ADDENDUM No. 1
Central Avenue Stormwater Improvements
CITY OF LAKE STATION
PROJECT NUMBER: 2022.00047

OCTOBER 14, 2025

CITY OF LAKE STATION
1969 CENTRAL AVE.
LAKE STATION, IN
46405

CURB AND GUTTER, CONCRETE
- C2

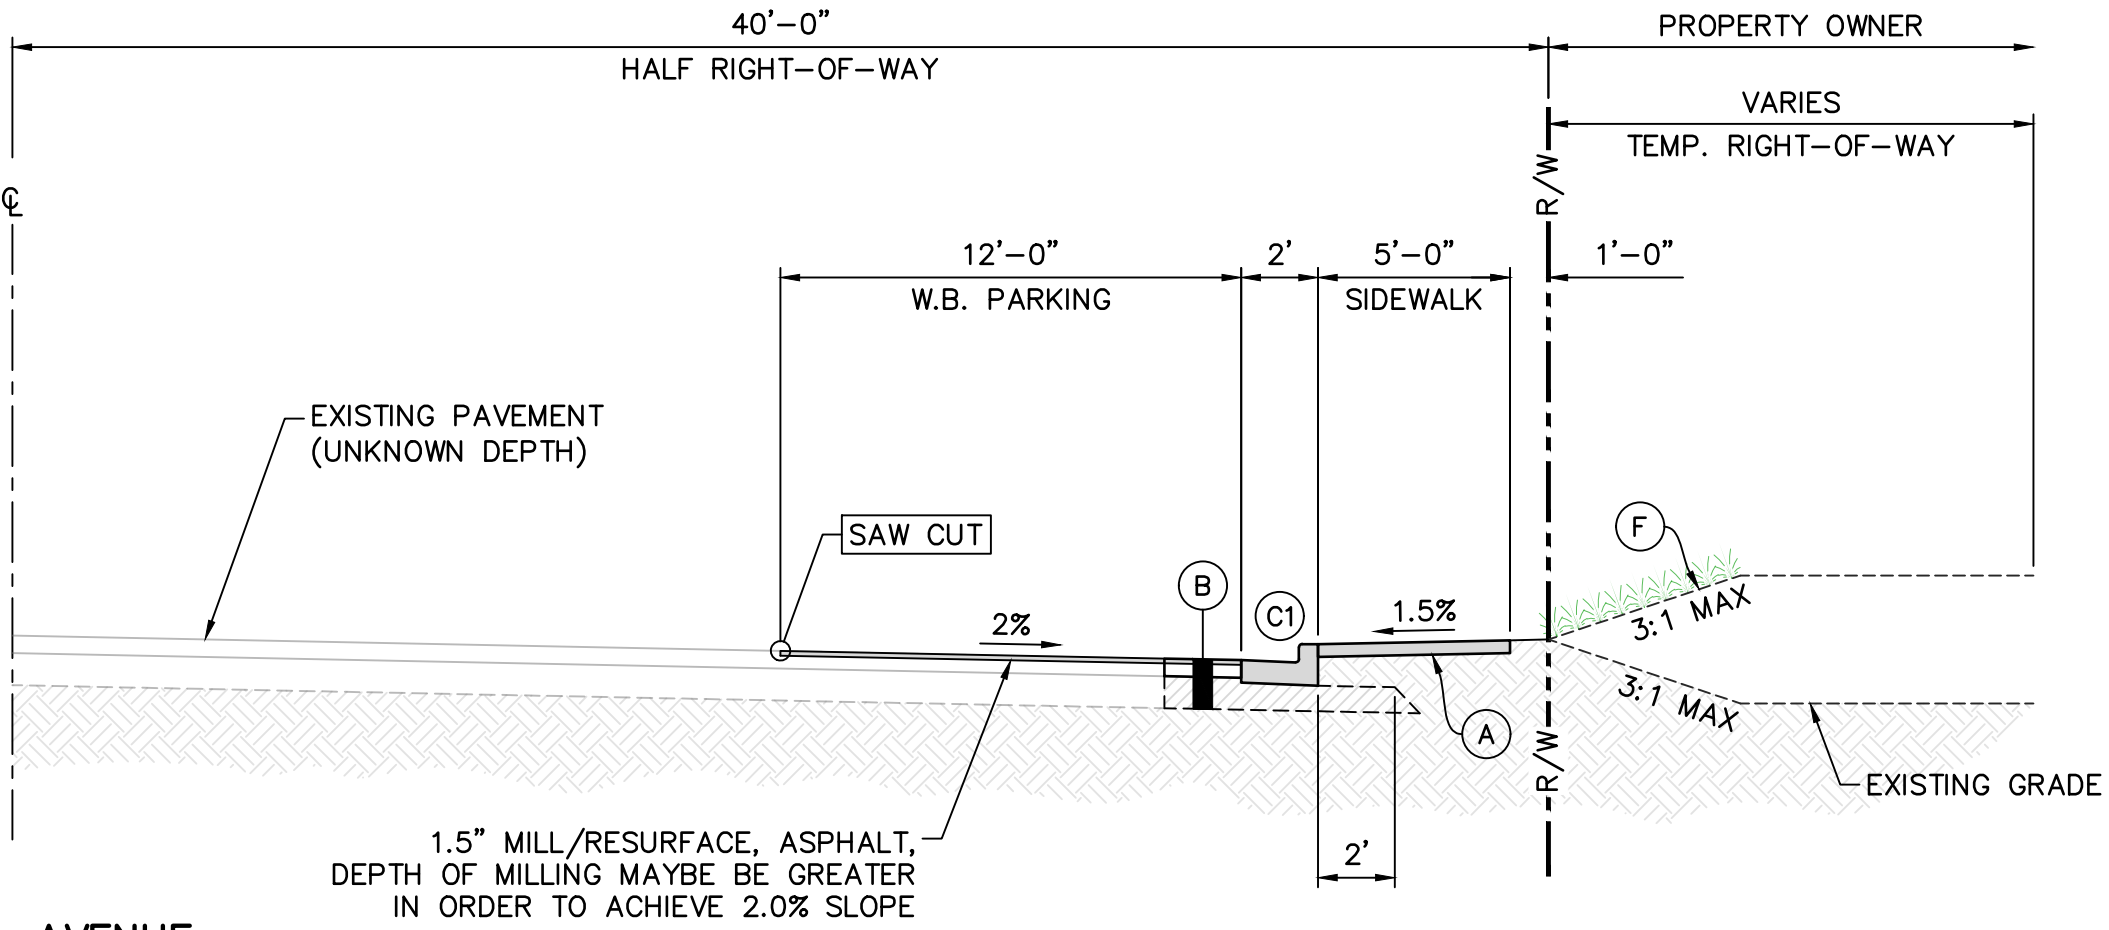
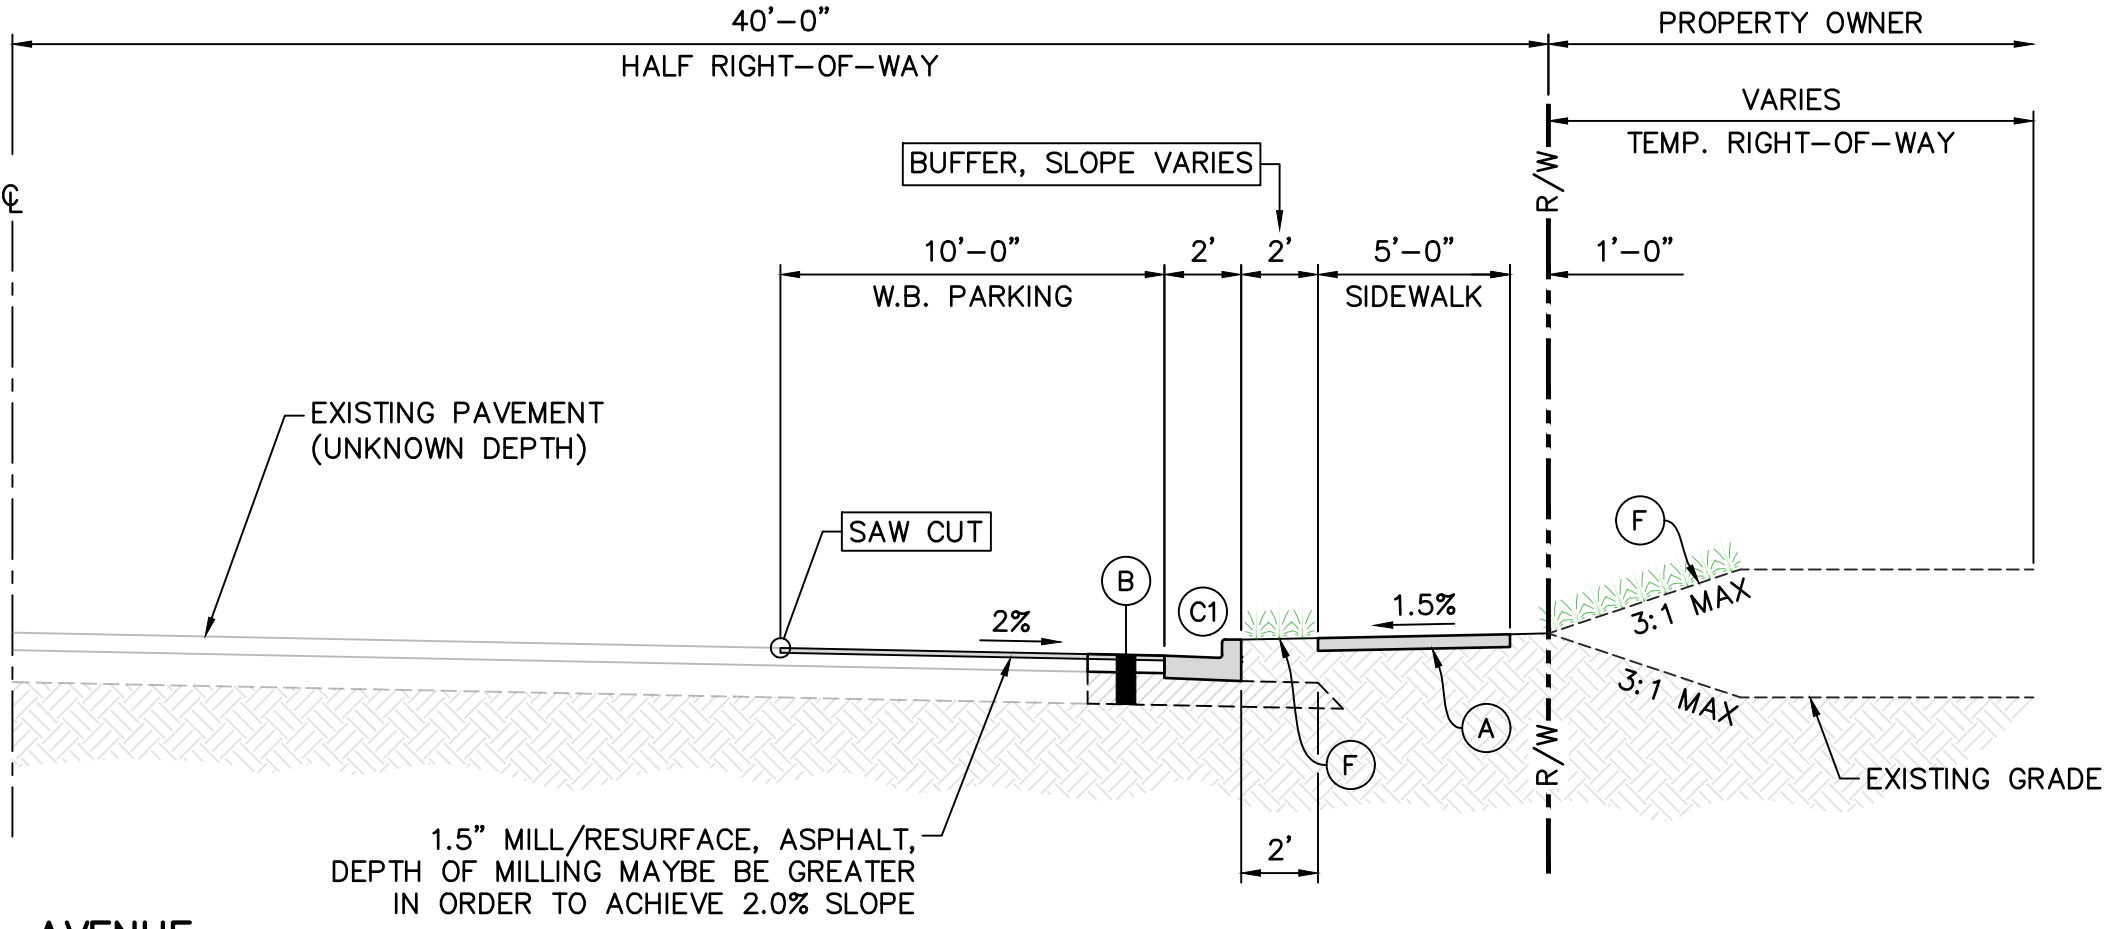
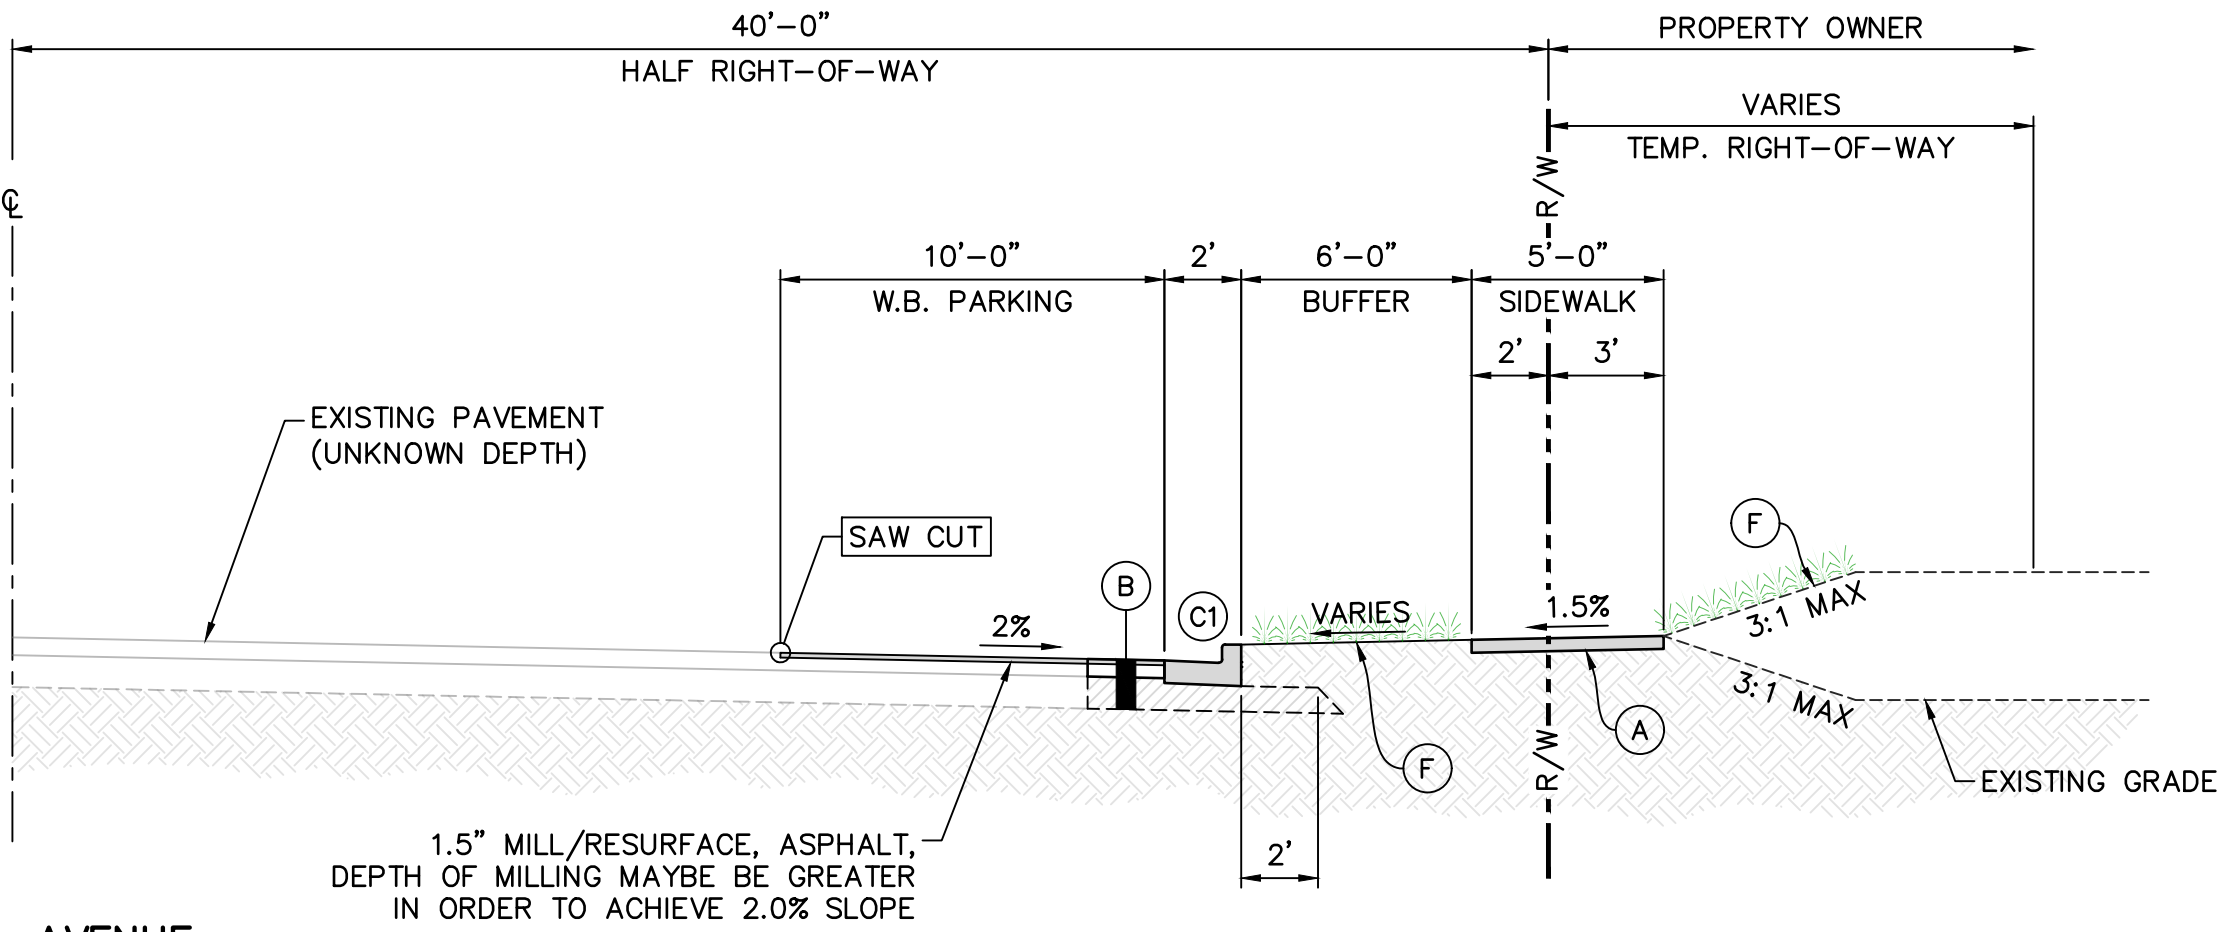
30. **Question:** C-203 states that the depth of the milling may be greater to achieve 2% slope on Central Ave: Will the engineer provide curb elevations for the work on Central Avenue?

31. **Question:** C-203 states that the depth of the milling may be greater to achieve 2% slope on Central Ave: Will the Engineer provide revised elevations based on actual road elevations?

32. **Question:** C-203 states that the depth of the milling may be greater to achieve 2% slope on Central Ave: Will this additional depth be paid separately?

Answer: No

Answer: Revised elevations will be provided by the Engineer as required.

Answer: Yes, if approved by the Owner and Engineer, then it will be paid for separately.

C-204

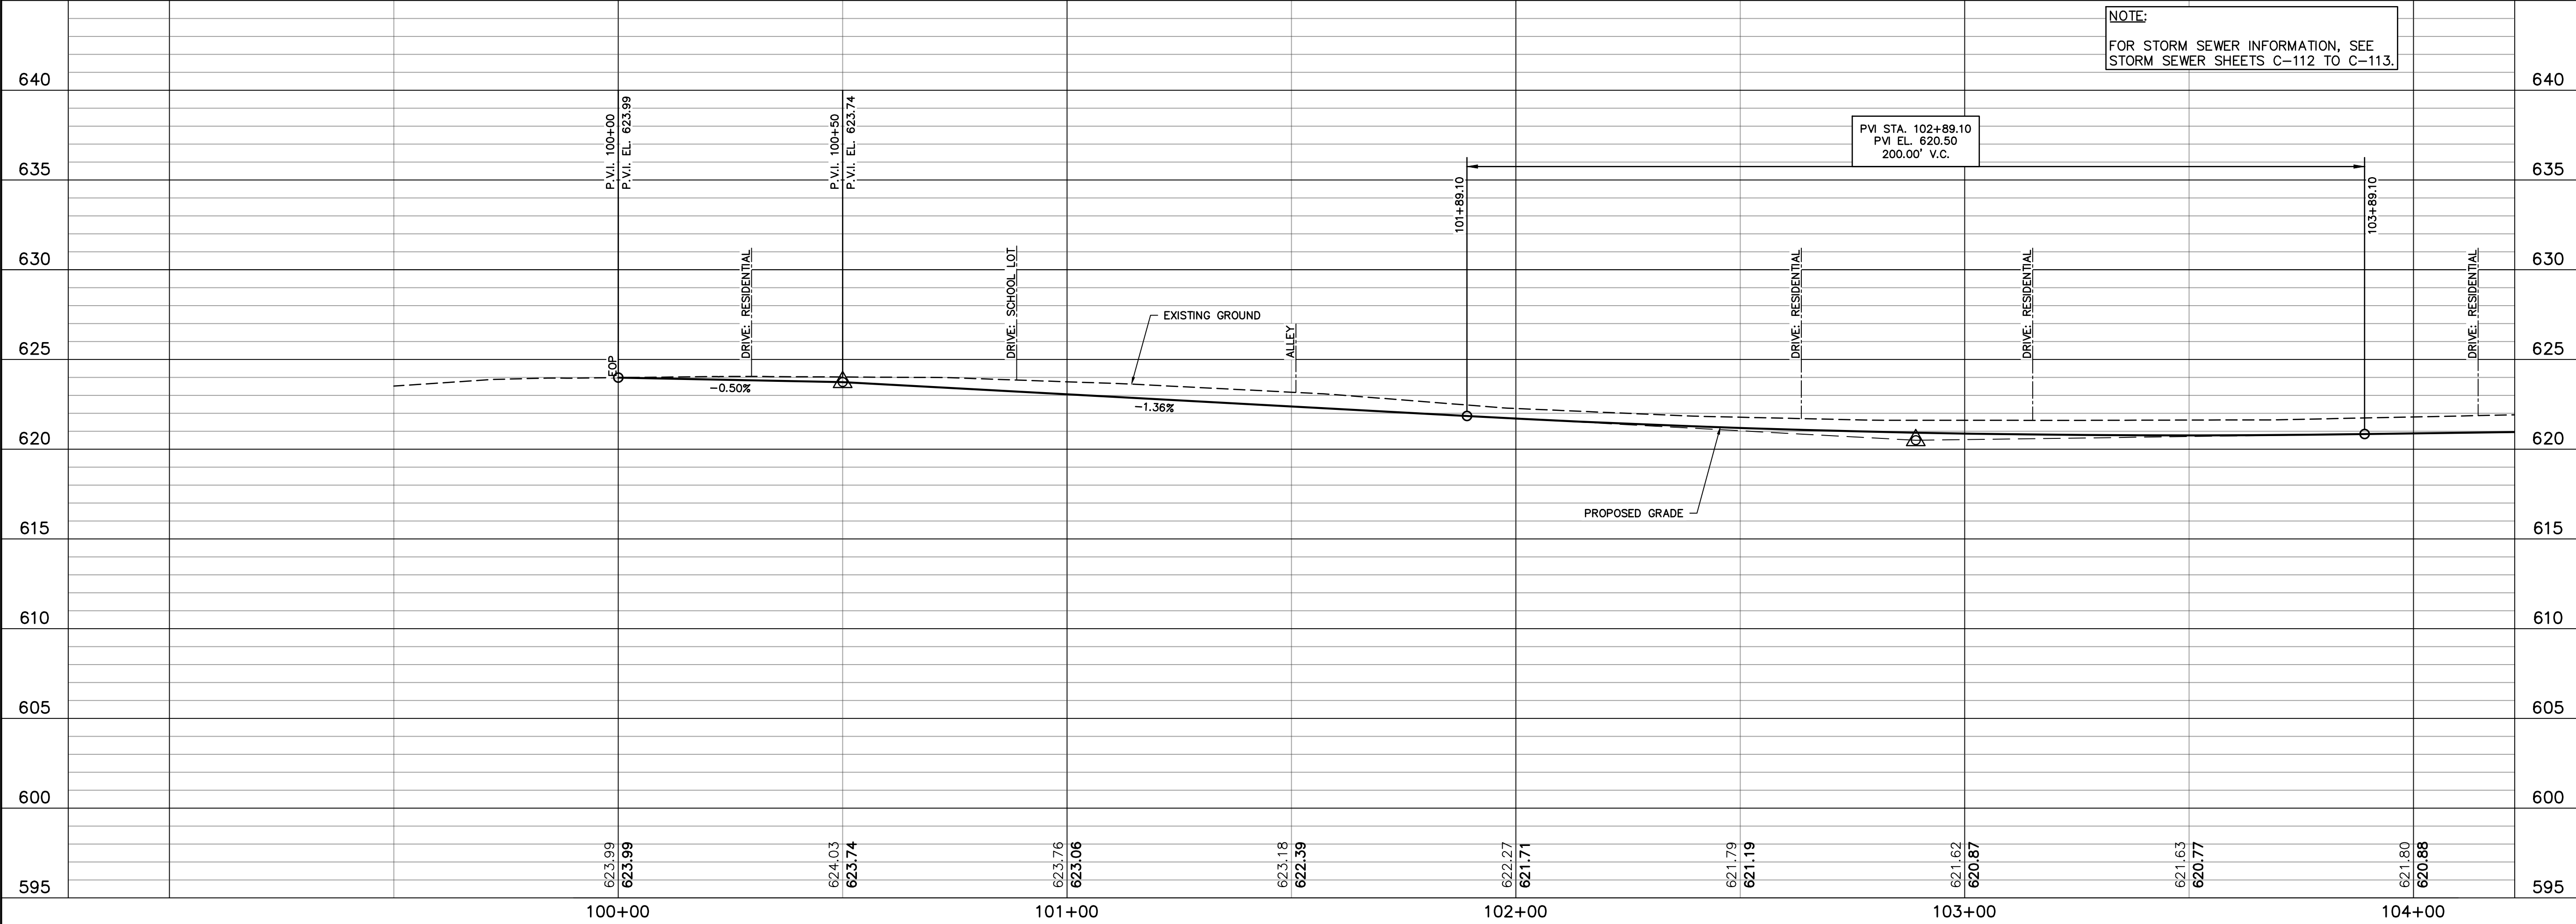
1. Replace sheet C-110 thru C-112 with revised sheets noting all 30" to 36" pipe material shall be either RCP or PVC.
2. Replace sheets C-122 with revised sheet C-122 noting all 30" to 36" pipe material shall be either RCP or PVC.
3. Replace sheet C-125 with revised sheet C-125 noting stone to be used under manholes.
4. Replace sheet C-127 with revised sheet C-127 noting the updated pipe bedding and backfill detail.
5. Replace sheet C-201 thru C-203 with revised sheets noting the revised aggregate subbase in the typical sections.
6. Replace sheet C-204 with revised sheet C-204 noting the removal of the gas relocation.

CURB TRANSITION DETAIL
NOT TO SCALE

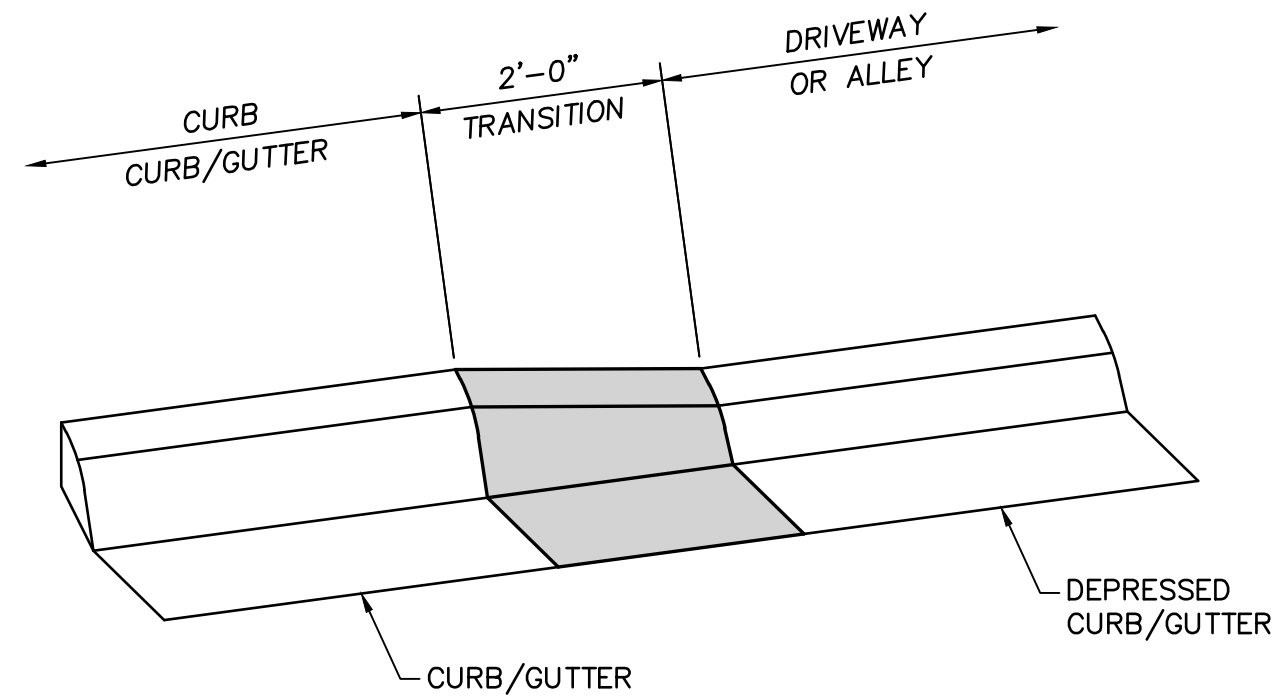
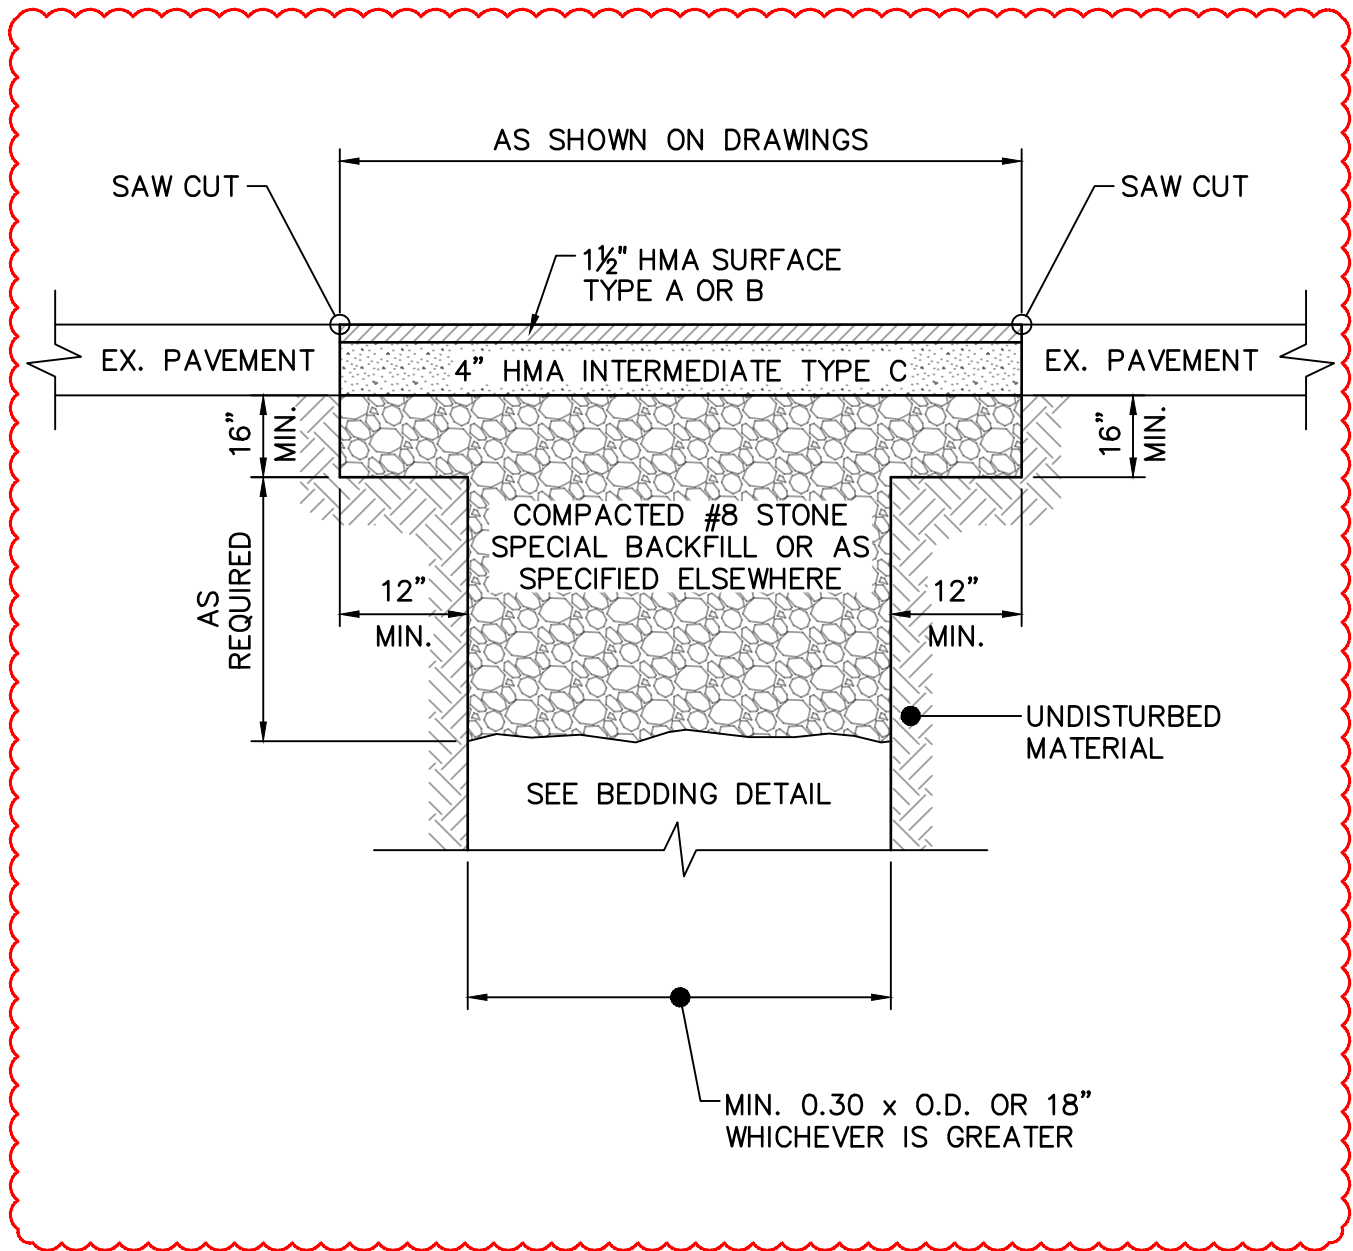
7. **Question:** Please add a bid item for “Depressed Curb” for the Combined Curb & Gutter.
Answer: Use the existing pay items. See sheet 229 of the construction plans for the curb transition detail.
